TYPE II VARIANCE REQUEST

RE: Polaris Pointe – Phase I (8886 Lyra Drive)
CC# 17376
PID# 31843101017000

We submitted a request for a Type II Variance from the City of Columbus' Storm Water Drainage Manual on 4/1/16. We have since received comments and request for additional information on 5/3/16 from the Variance Committee on the initial submittal. We would like to respond, in detail, to each specific comment below:

PROJECT TITLE: PRIVATE STORM SEWER FOR POINTE AT POLARIS PHASE I 8886 LYRA DRIVE GRADING PLAN			
DIVISION USE ONLY		OWNER	
		CONTRACTOR	
		INSPECTOR	
		AGREEMENT	COMPLETED
		RPD	CHK
		INDEX	CON.DR.
		DETAIL	RECORD
			FILE

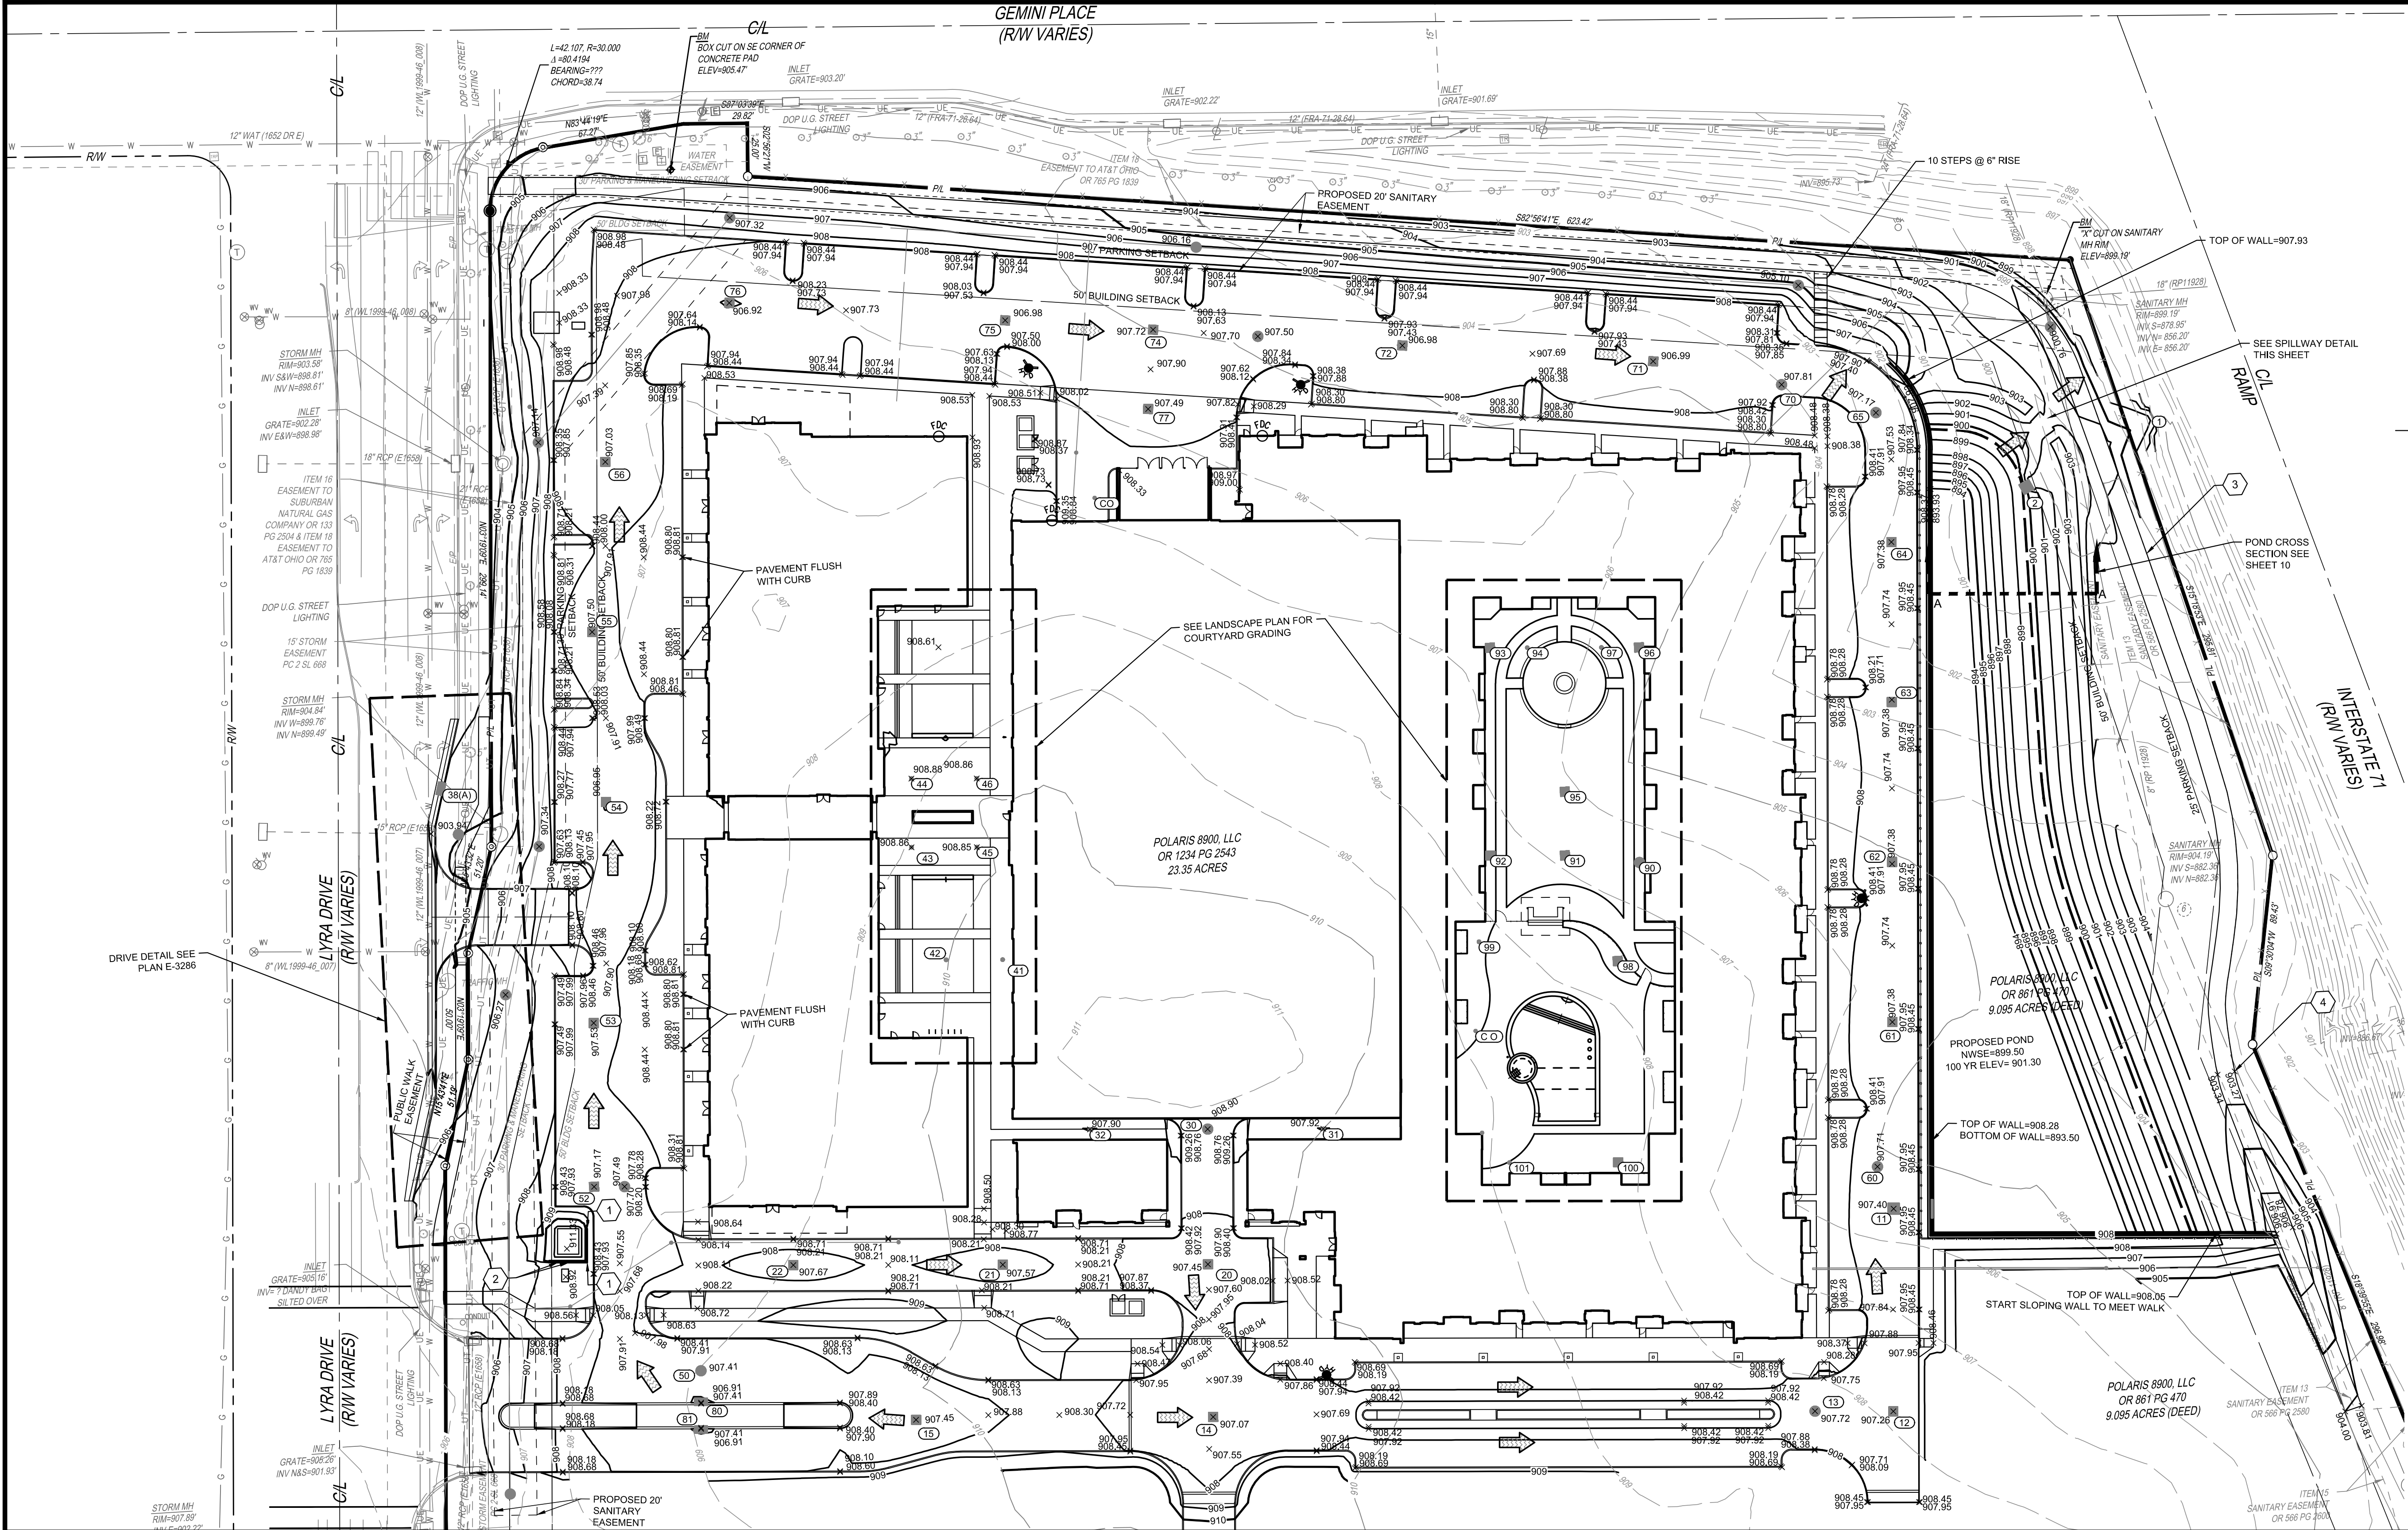
11. No dimensions, wall heights, total water depth, etc. were included in the variance narrative.

Based on review of the attached exhibits with difficult text size it appears the proposed retaining wall is approximately 15 feet in height which creates a high safety risk. In addition, the daily normal pool depth of 6 feet increases to nearly 8 feet during a 100 year storm event. There was a lack of discussion or detail of how the proposed wet basin is accessible in either “emergency” or “maintenance” conditions. The exhibits were not clear as to whether there is an adequate maintenance access along the proposed basin’s perimeter.

We did not intend to provide unclear data. We just believed that the overall intent was to be shown in the variance request as we have submitted fully scalable drawings for the storm water review. However, please reference full sized sheets attached that can be better read and dimensioned. These are a portion of the overall storm CC plans. The overall wall height is approximately 15’ from the bottom of the pond. The normal pool depth is 6’ and increases to 8.5’ during the 100-yr storm event.

For emergency or maintenance conditions, the pond can be accessed via the paths located south of the pond and also at the NW corner of the pond. We are showing an 8’ wide asphalt multi-use trail that runs along the north and east sides.
